Whiz New Features

SW 1.16 Version
Release Note

THANK YOU FOR USING OUR AI
CLEANING COBOT WHIZ. BRAIN OS
(VER1.16.24) INCLUDES UPDATES AS
FOLLOWS:

LTE Signal Display Update

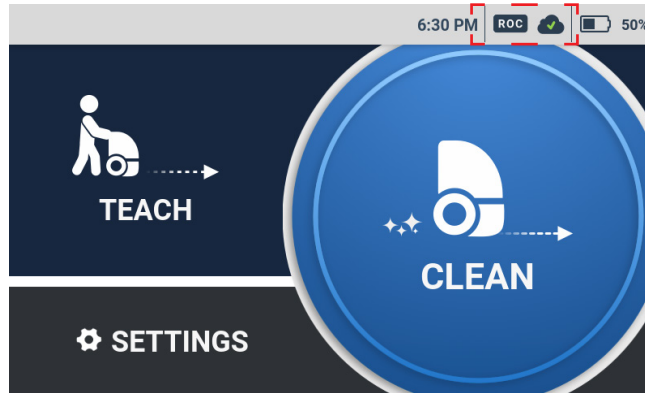
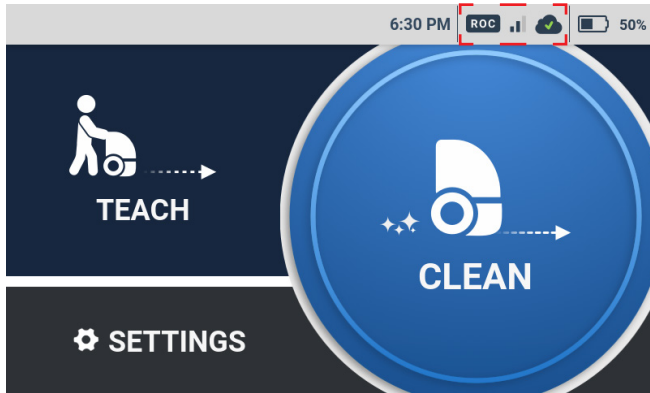
LTE Signal Display has been updated. It is possible to check the current LTE status by the following steps SETTINGS → ABOUT Wireless, Signal Strength. The signal strength bars shown on the status bar at the top of the screen is deleted.

Wireless: Connected to LTE 接続済/
Not connected to LTE

Signal Strength: xx dBm
